Subject: Duke Energy Carolinas, LLC
William States Lee III Nuclear Station - Docket Nos. 52-018 and 52-019
AP1000 Combined License Application for the
William States Lee III Nuclear Station Units 1 and 2
Response to Request for Additional Information
Ltr# WLG2010.07-08

Reference: Letter from Sarah Lopas (NRC) to Bryan Dolan (Duke Energy), Request for
Additional Information Regarding the Supplement to the Environmental Report
for the William States Lee III Nuclear Station, Units 1 and 2, Combined License
Application, dated June 22, 2010 (ML101370398)

Lee Nuclear Station Response to Request for Additional Information (RAI)

<p>WILLIAM STATES LEE III NUCLEAR STATION UNITS 1 & 2</p>
<p>River Water Intake Structure</p>
<p>FIGURE 5.3-1 - Sheet 1 of 2 Rev 2</p>

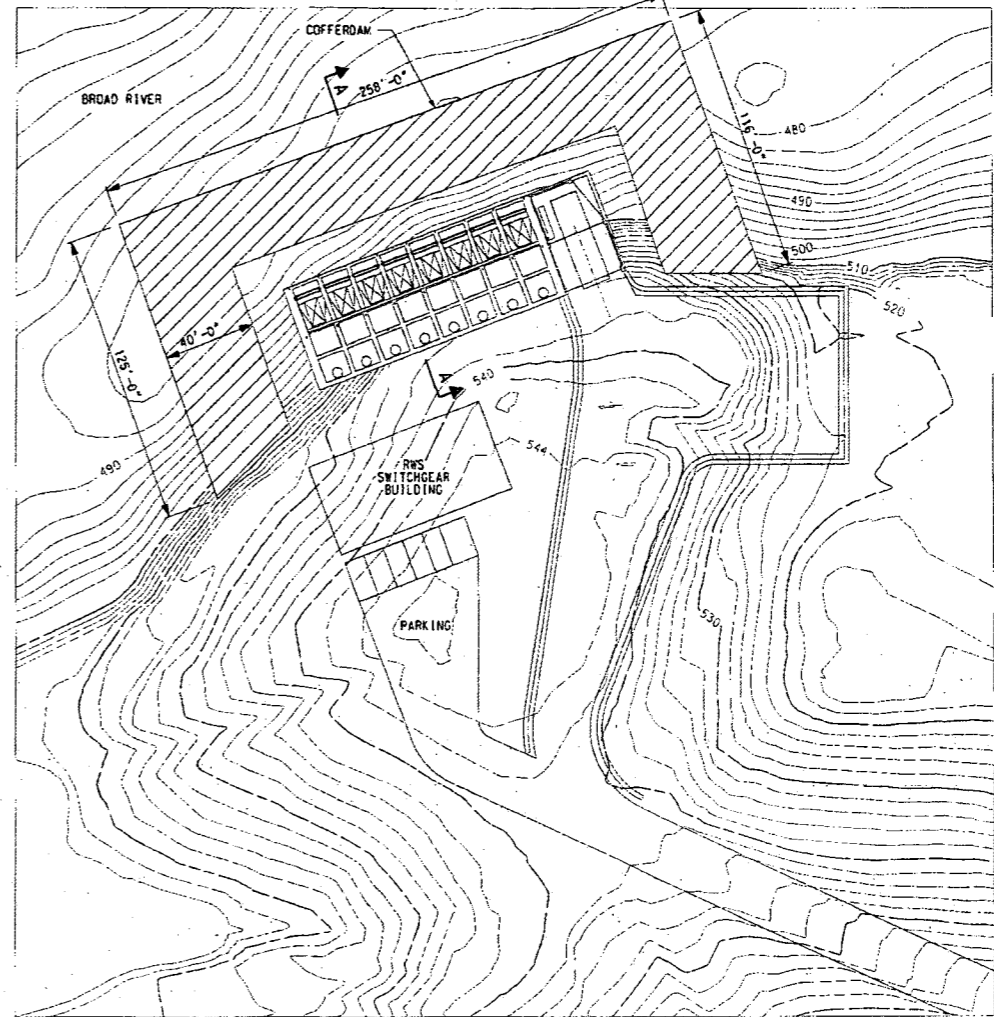
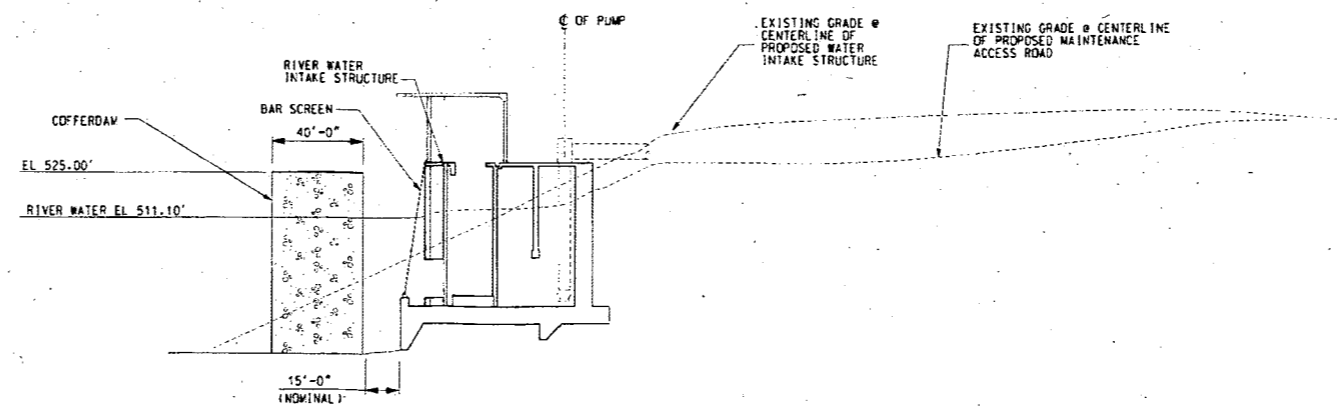
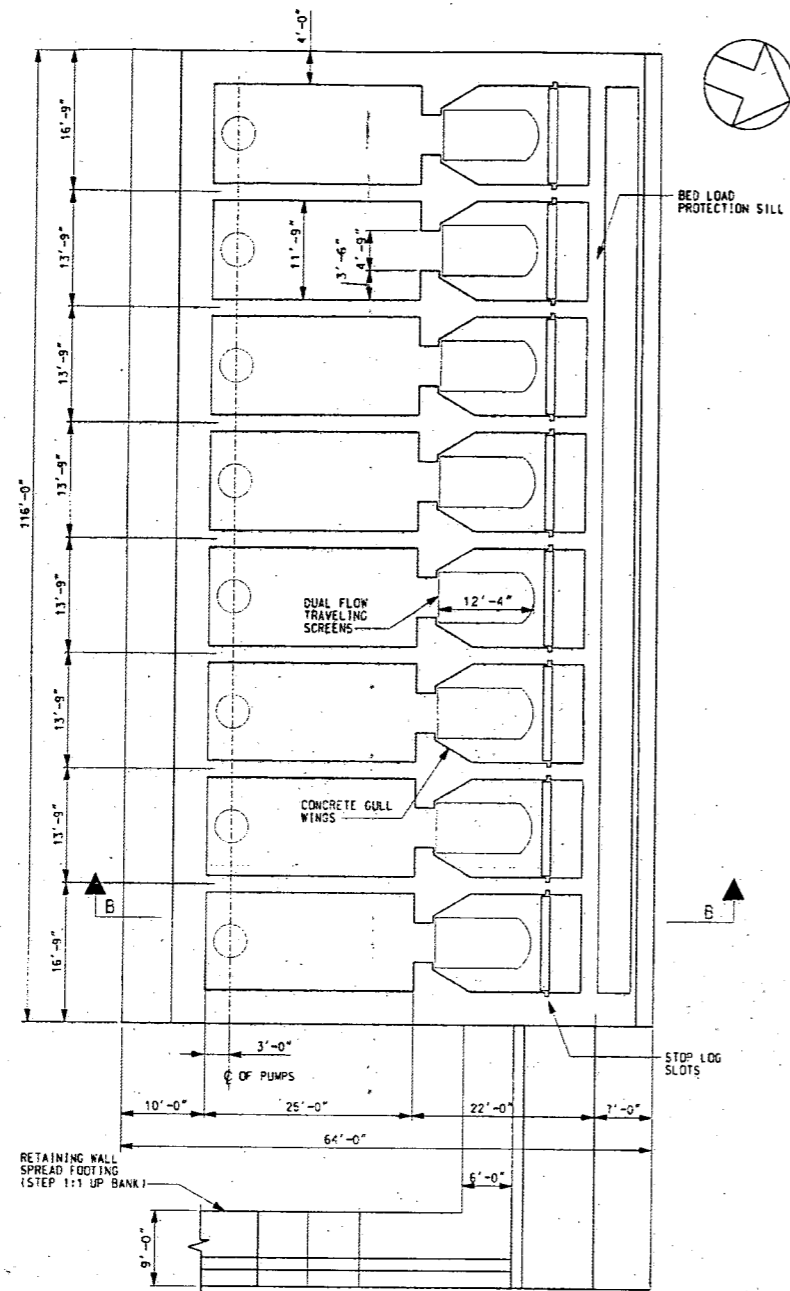
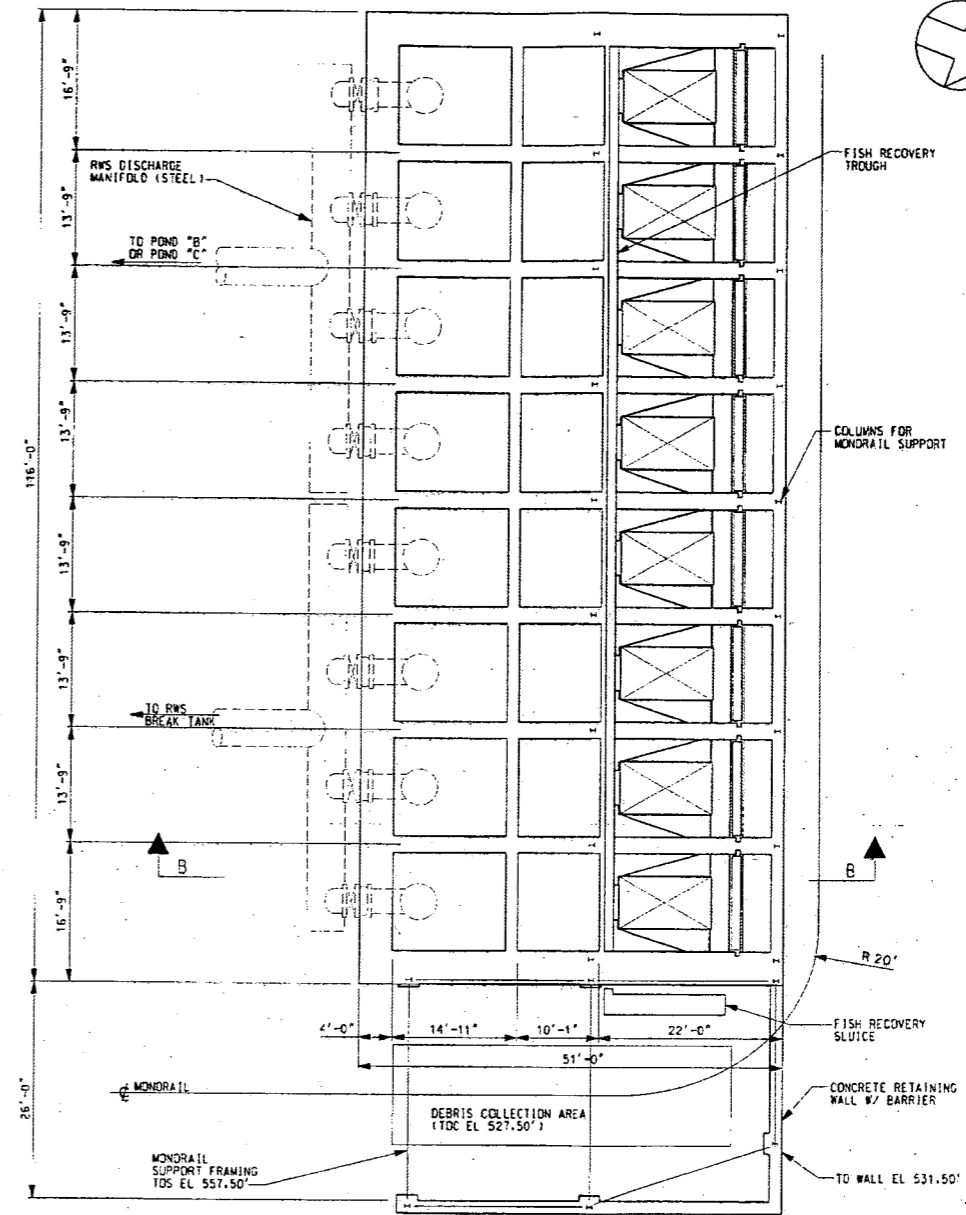
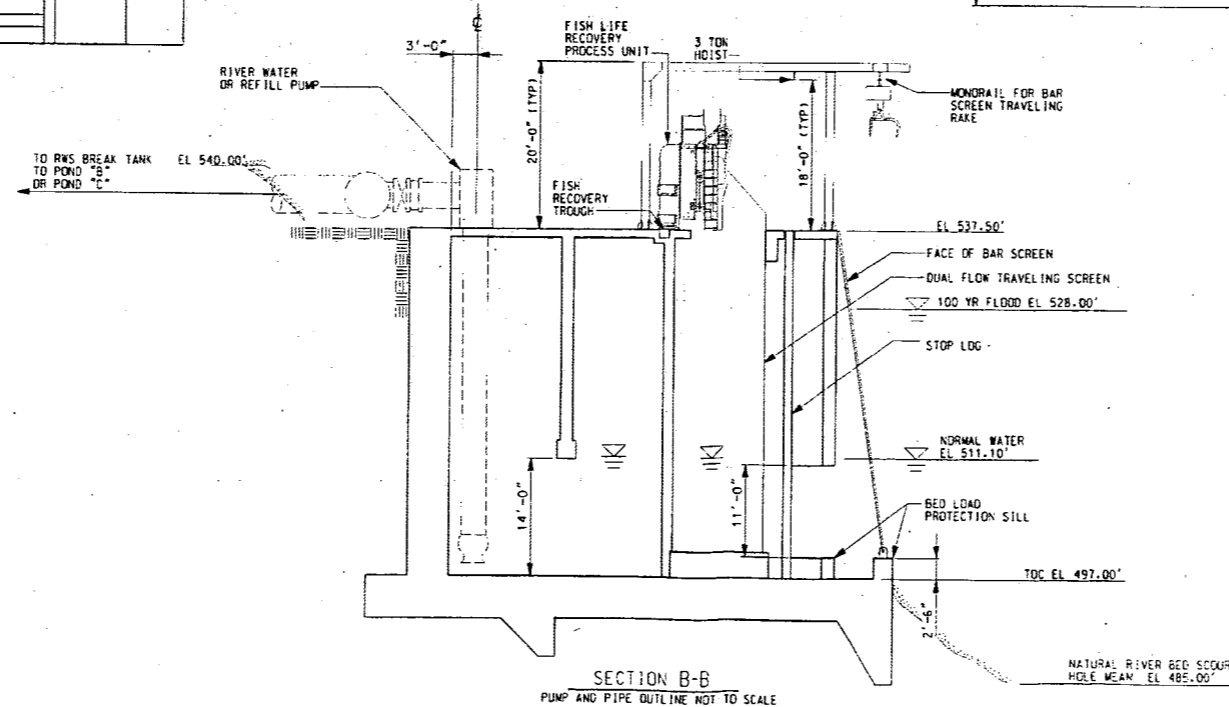
Provide physical descriptions (e.g., location, dimensions, construction materials, pump systems) of the "River Water Intake Subsystem" and the "Refill Subsystem Intake" referred to in Supplemental ER Figure 3.3-1, Sheets 1 and 2.

The river intake is a single intake structure with two sections. One section is for the river water subsystem and the other section is for the refill subsystem. Each section has four forebays with a total of eight forebays for the intake structure. Attachment 190-01 provides a revised ER Figure 5.3-1 which shows the dimensions of the river intake structure. Figure 4.2-2 in the ER

Attachment 190-01 Lee Nuclear Station River Water Intake Structure (Revised ER Figure 5.3-1 Sheets 1 and 2)
